ADDENDUM 1 (PENDING DSA APPROVAL)

PROJECT: **Santa Ana College**
 Science Center

DATE: 8/23/2017

DSA File No.: 30-C2
DSA Applications No.: 04-115788
HGA Commission No.: 3584-001-00

A421

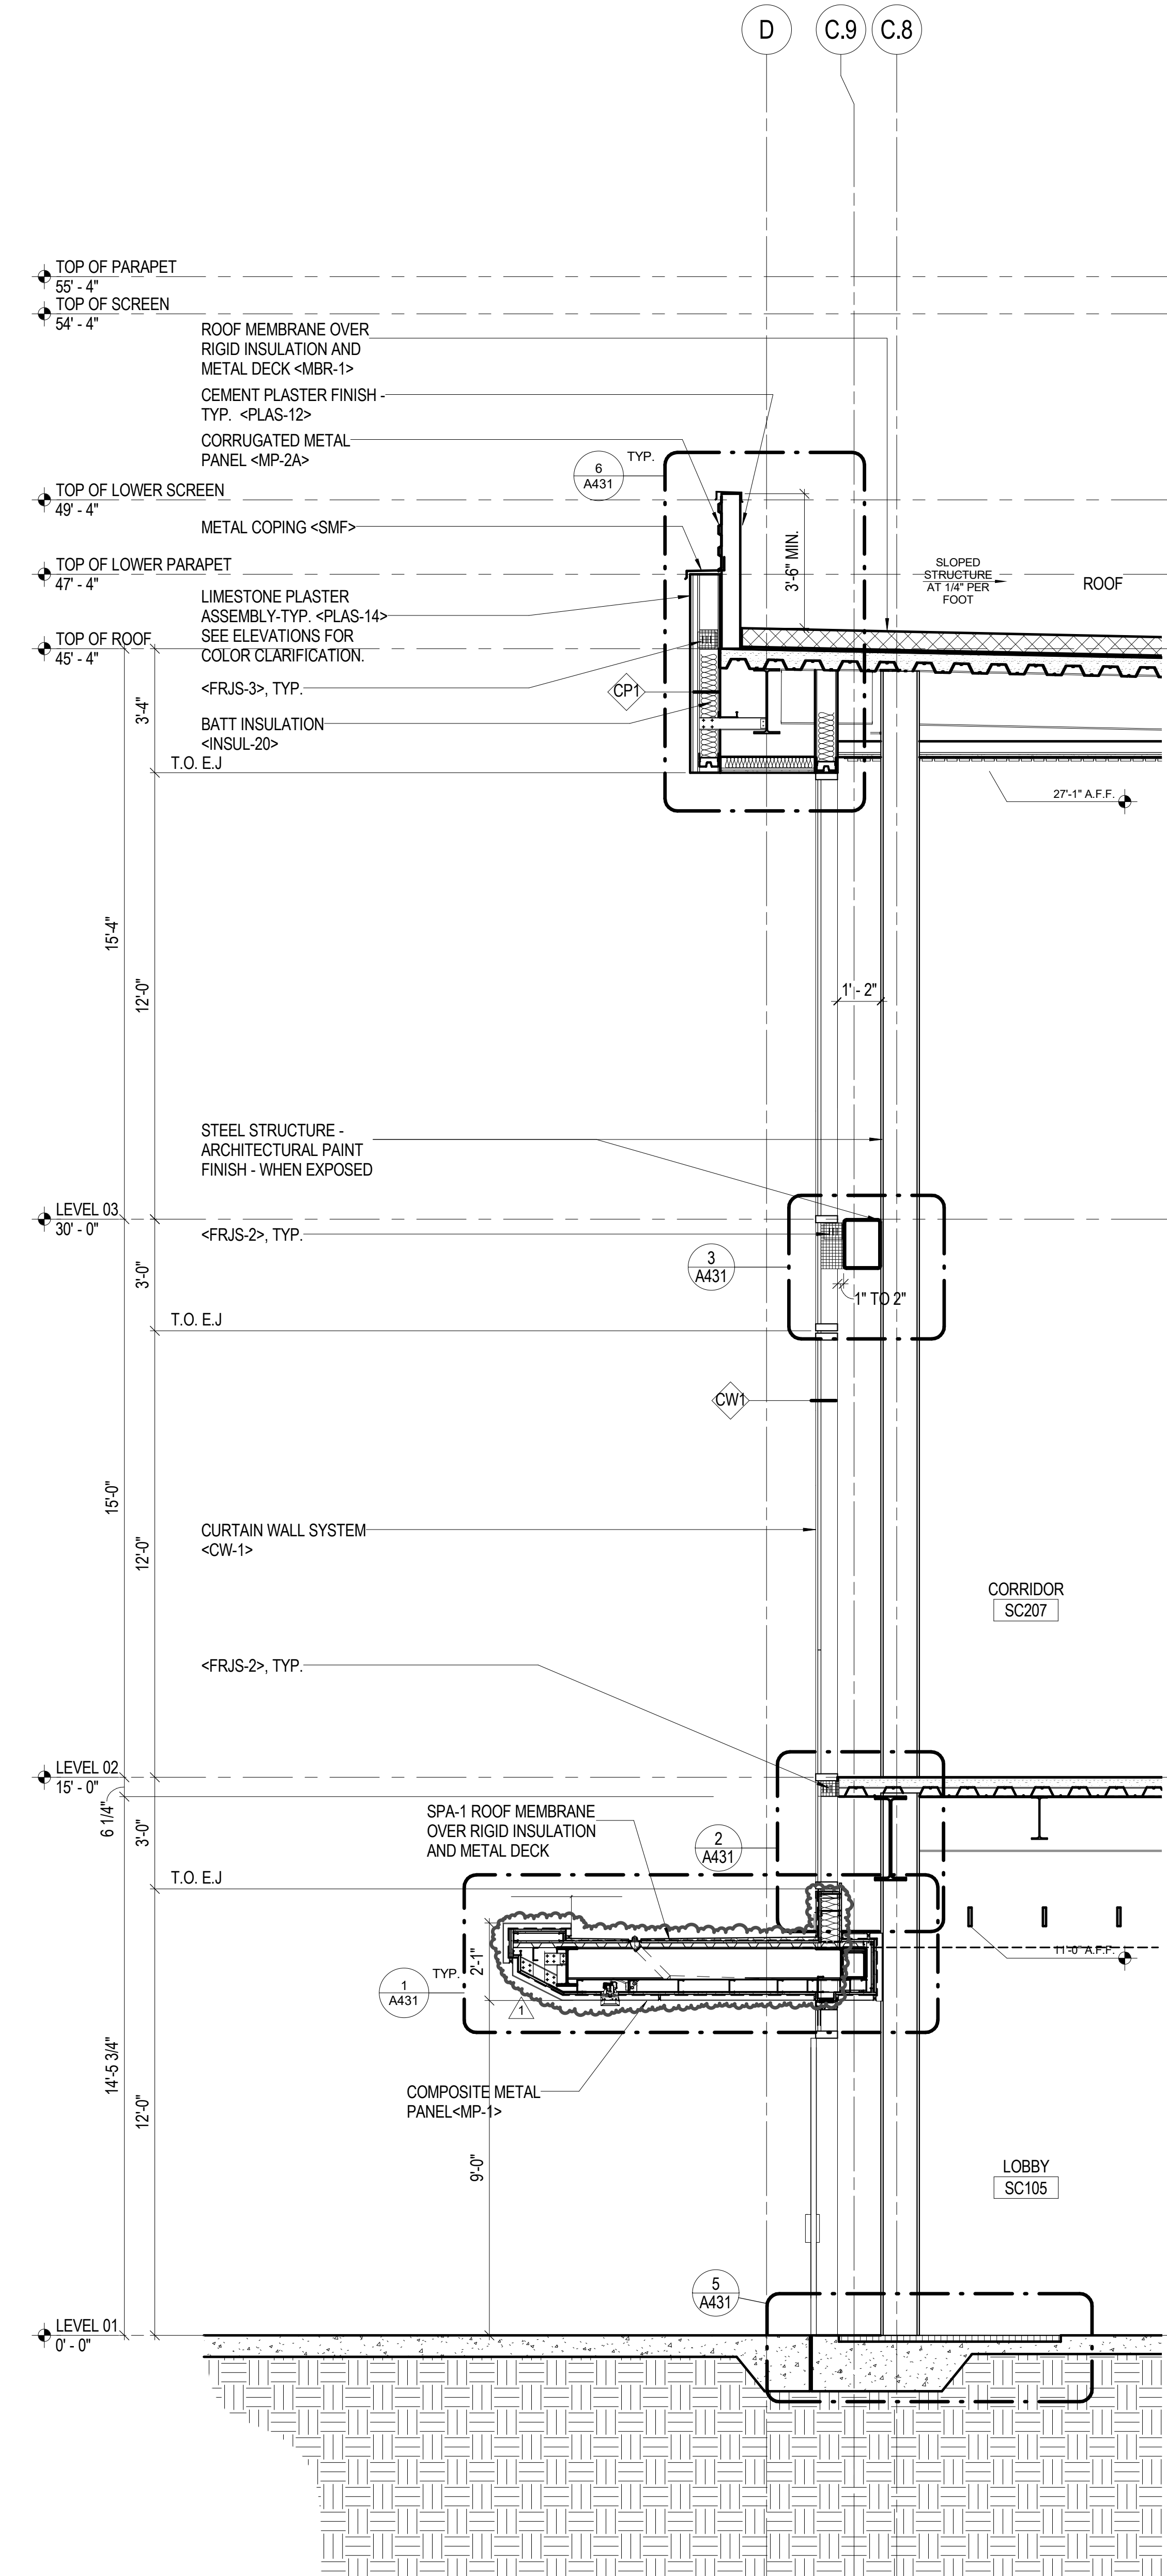
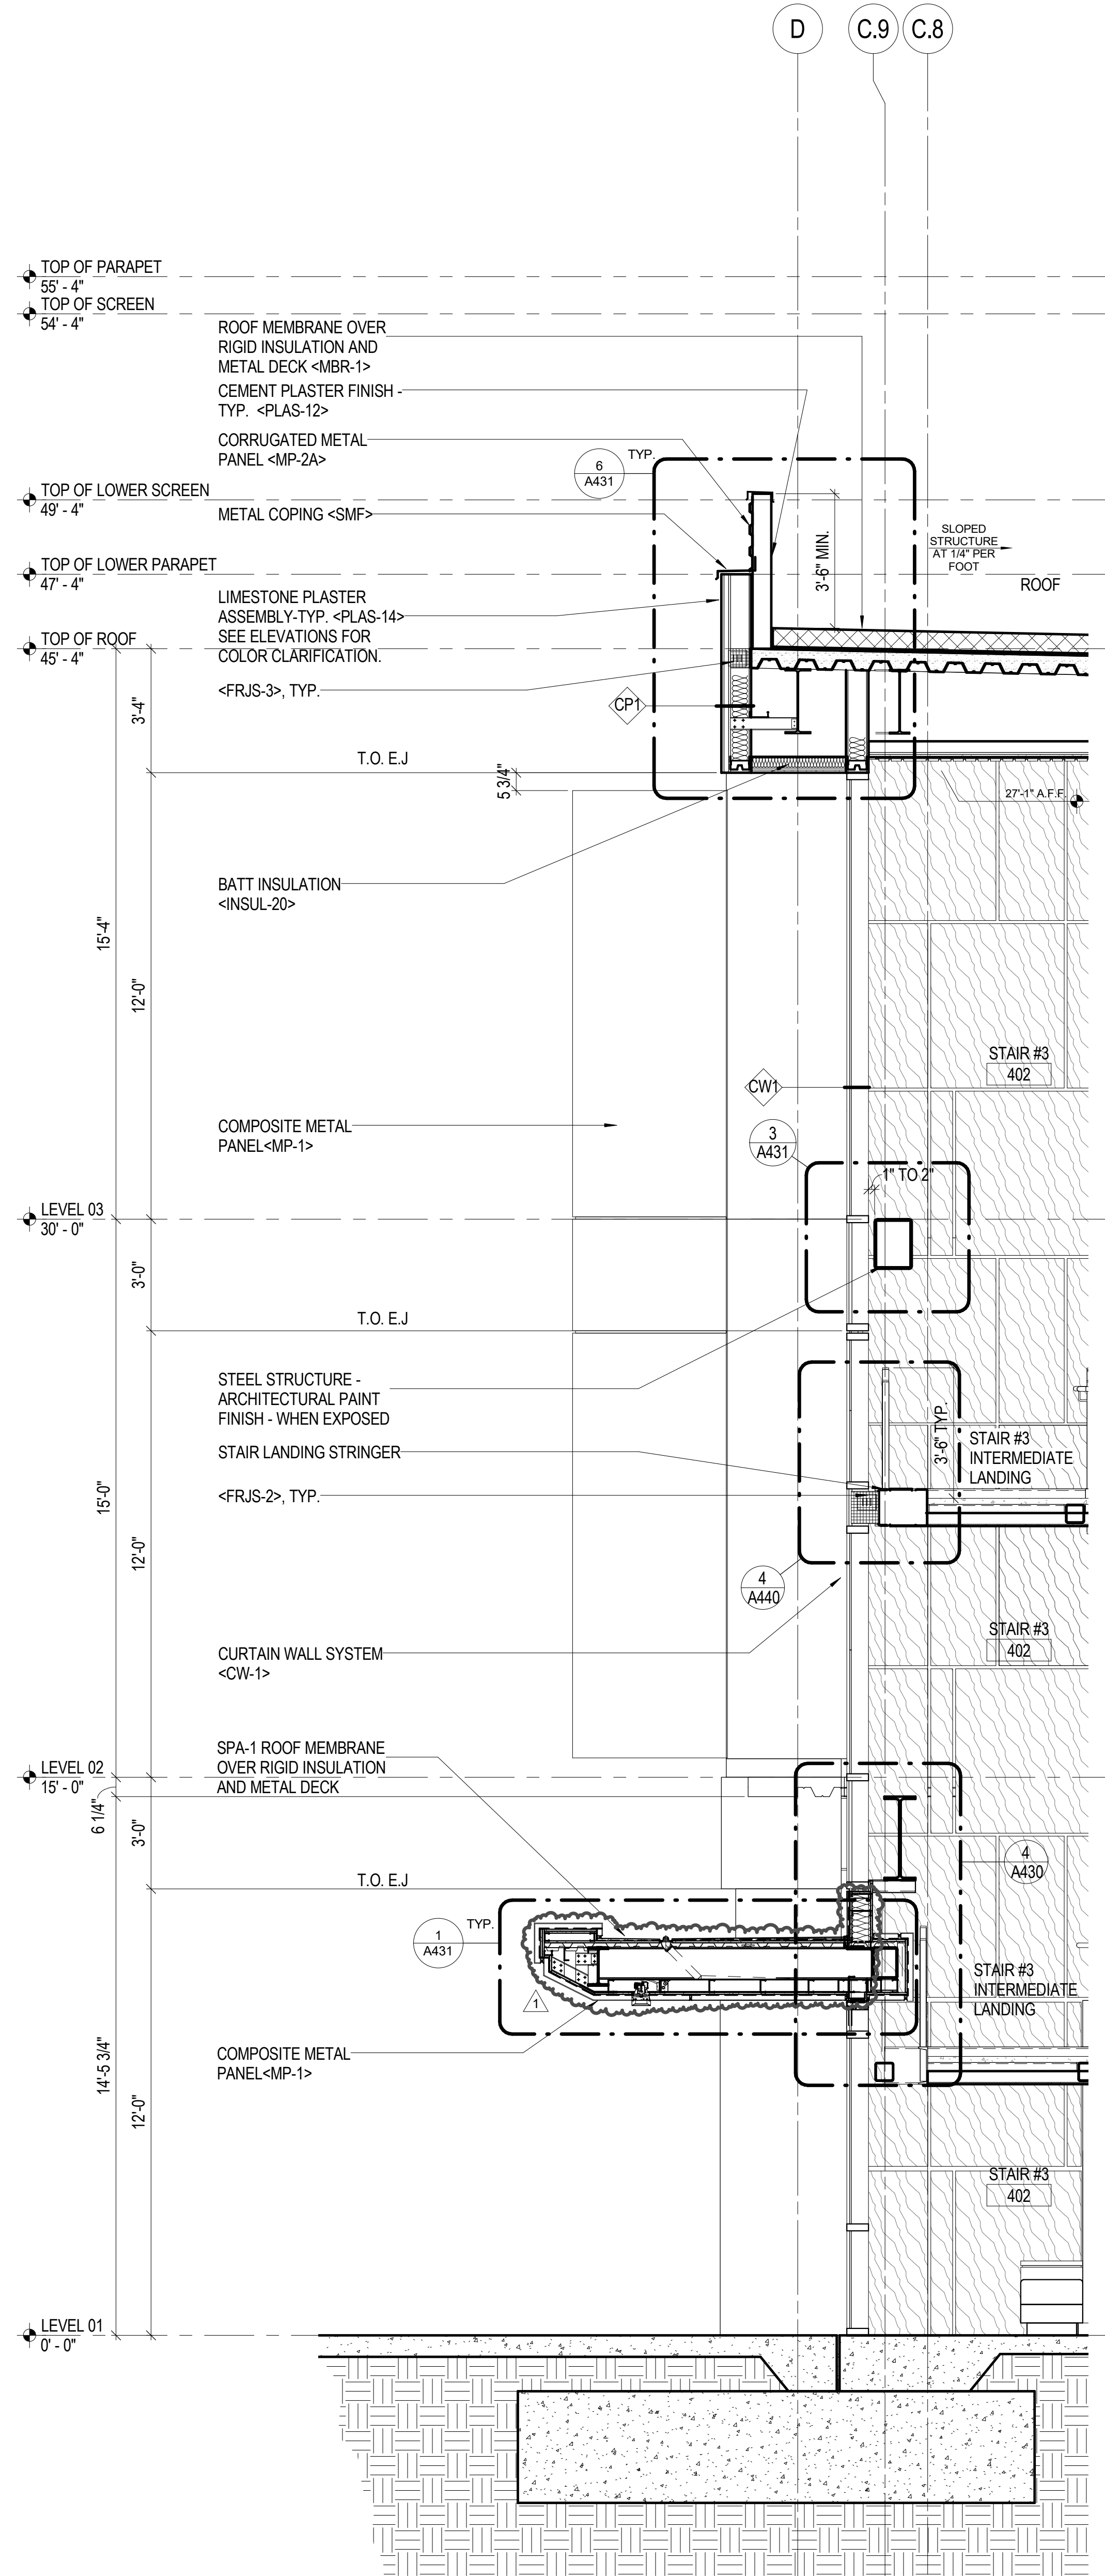
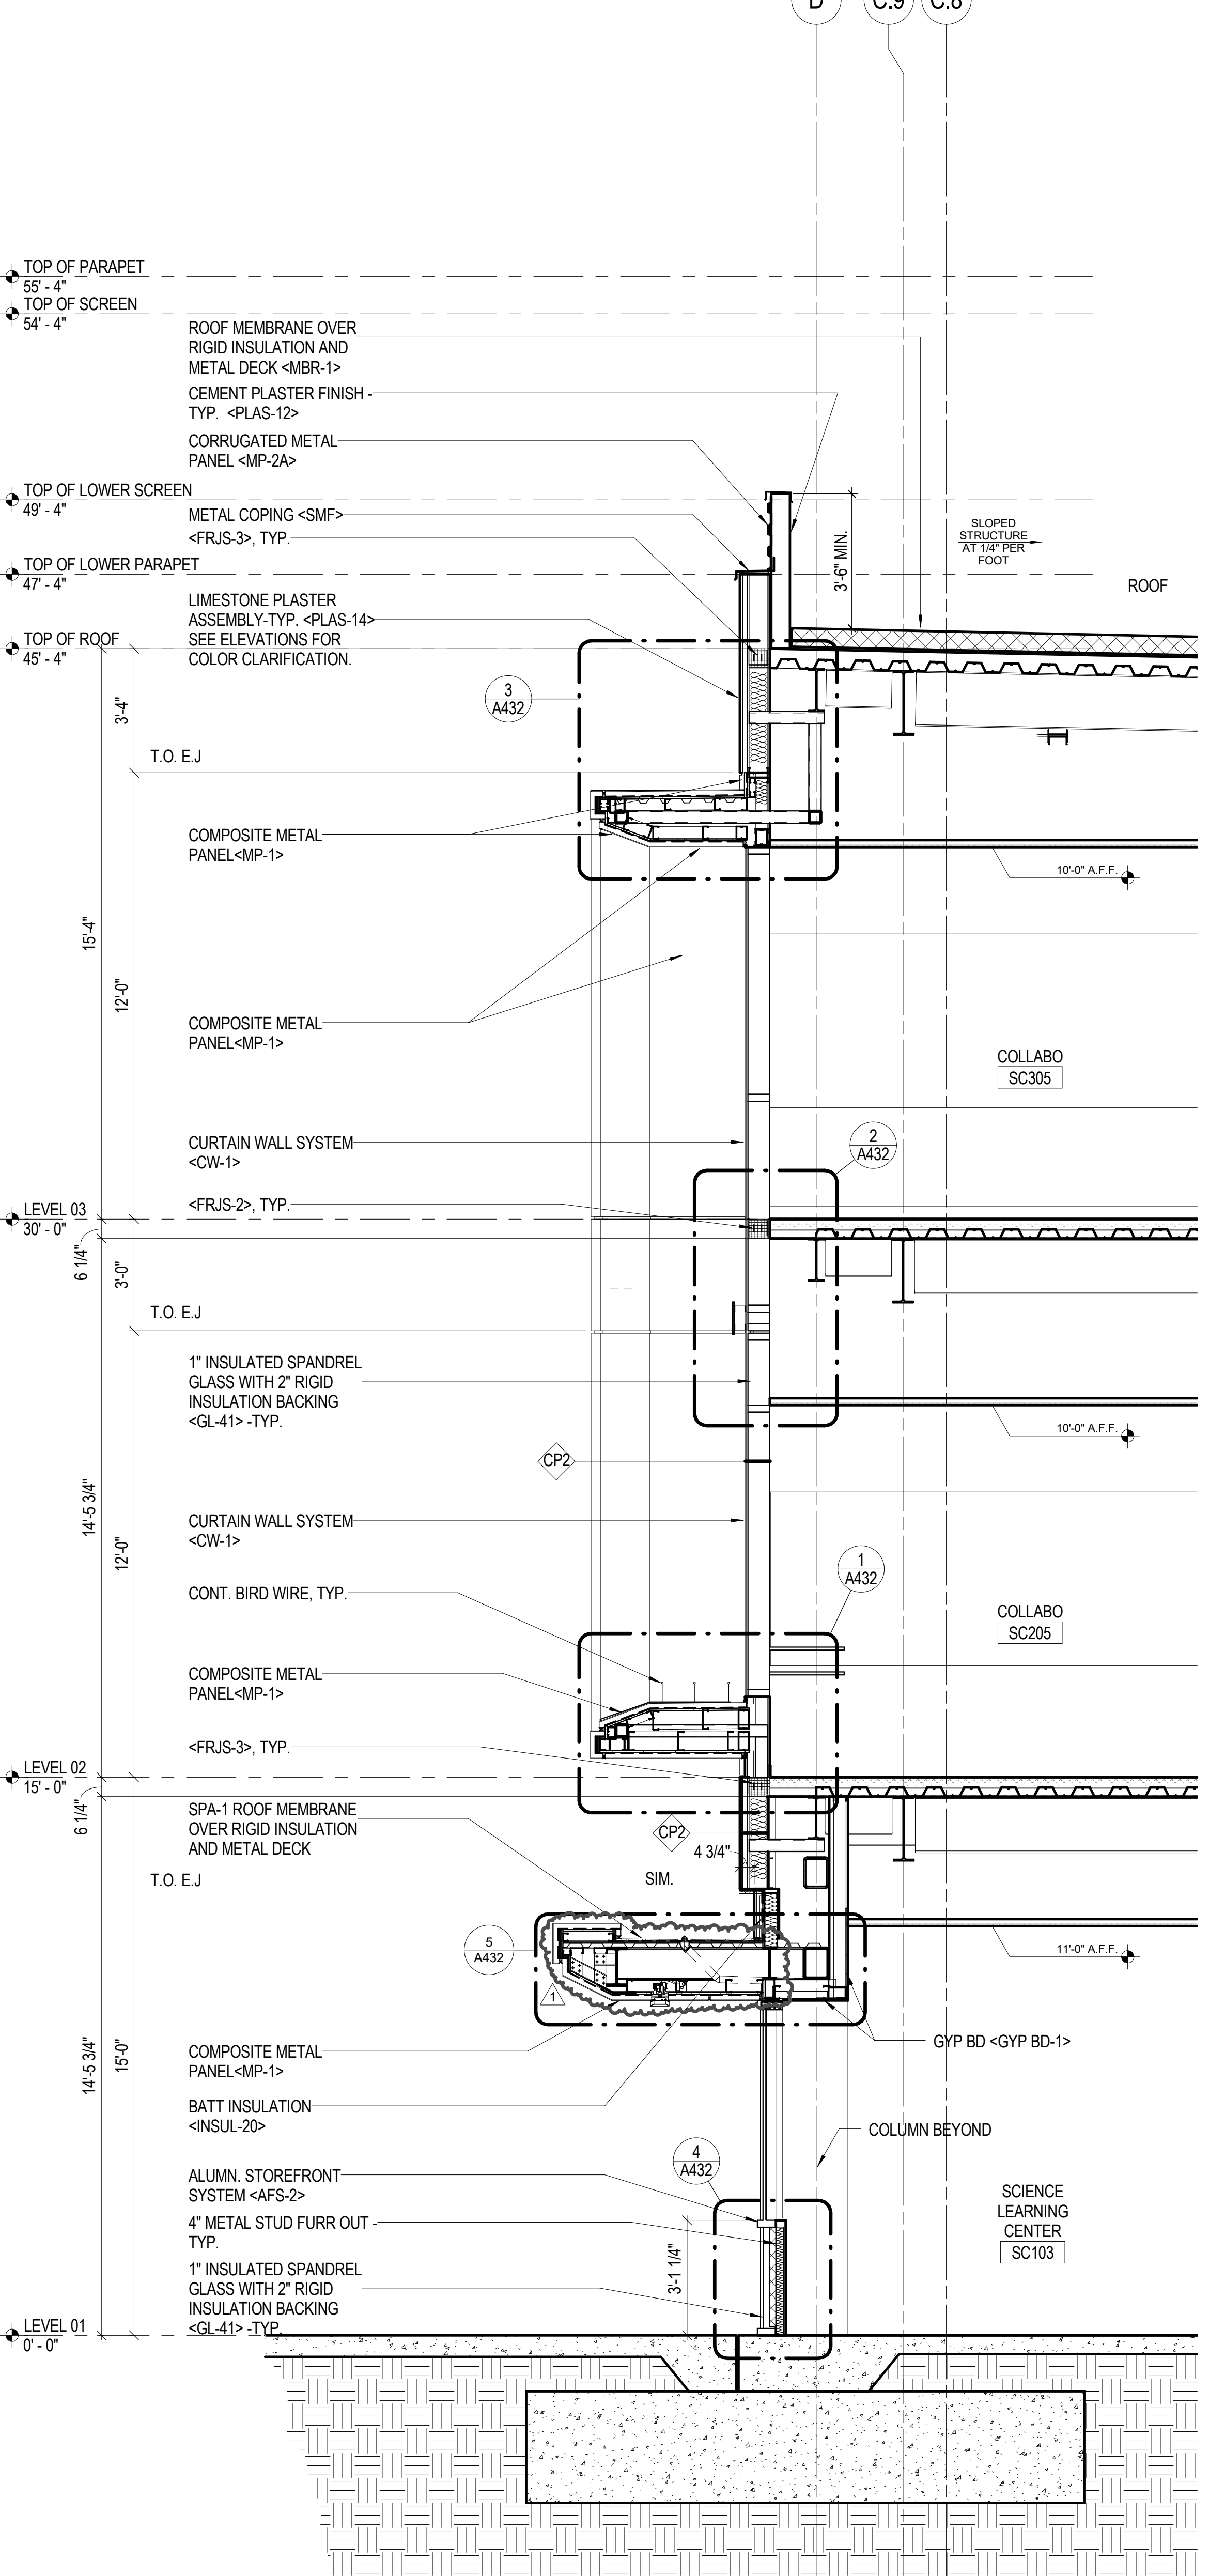
- North canopy reduced by 5'-0" at Details 1, 2, and 3.
- Gutter removed from roof at north canopy at Details 1, 2, and 3.
- Framing at canopy revised to match structural drawings at Details 1, 2, and 3.
